NS-EPR-2877

January 17, 1984

The subject of my August 6, 1982 letter to you (NS-EPR-2638) was the potential undetectable failure of a test switch in the Westinghouse Solid State Protection System (SSPS) which could affect Safeguards Actuation. A minor revision to test procedures was made to assure that a failure could not go undetected. No design changes were necessary to resolve safety concerns. Nevertheless, consideration of changes was initiated in the interest of prudent engineering.

This review is complete. A minor wiring change has been finalized by Westinghouse and is being forwarded to all affected plants. The change will assure that switch failure is easily detectable and will make revision of test procedures unnecessary.

OUTPUT RELAY TEST CIRCUIT
STANDARD 2-TRAIN SSPS

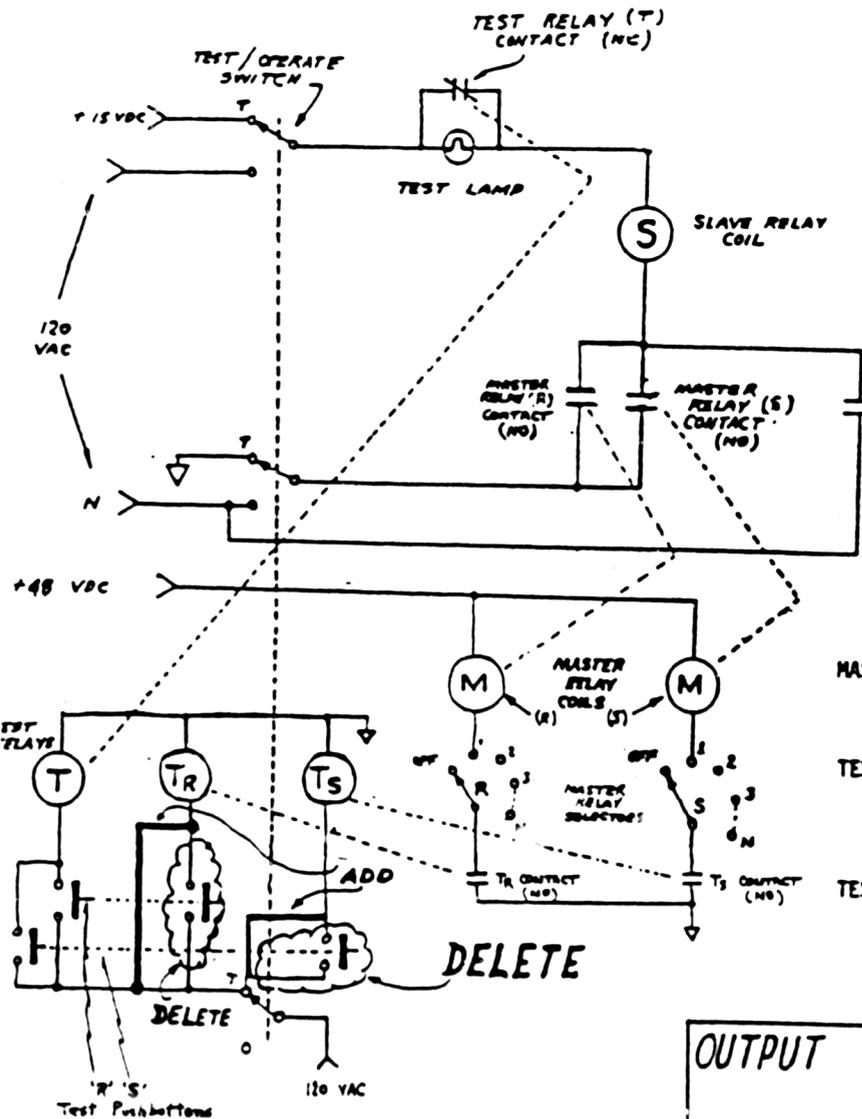
NOTE: MODE SELECTOR SWITCH IS SHOWN IN TEST POSITION

- TEST/OPERATE SWITCH TO TEST
- Slave 120 VAC reduced to 15 VDC
 - 48 VDC master relay ground returned
- MASTER RELAY SELECTOR SWITCH TO RELAY BEING TESTED
- Master relay energizes
 - Master relay contacts close 15 VDC to slave (Slave not energized on 15 VDC)
- TEST PUSHBUTTON DEPRESSED
- Test lamp ON confirms circuit and slave relay coil continuity.
- TEST PUSHBUTTON RELEASED
- Test lamp OFF confirms test lamp shunted
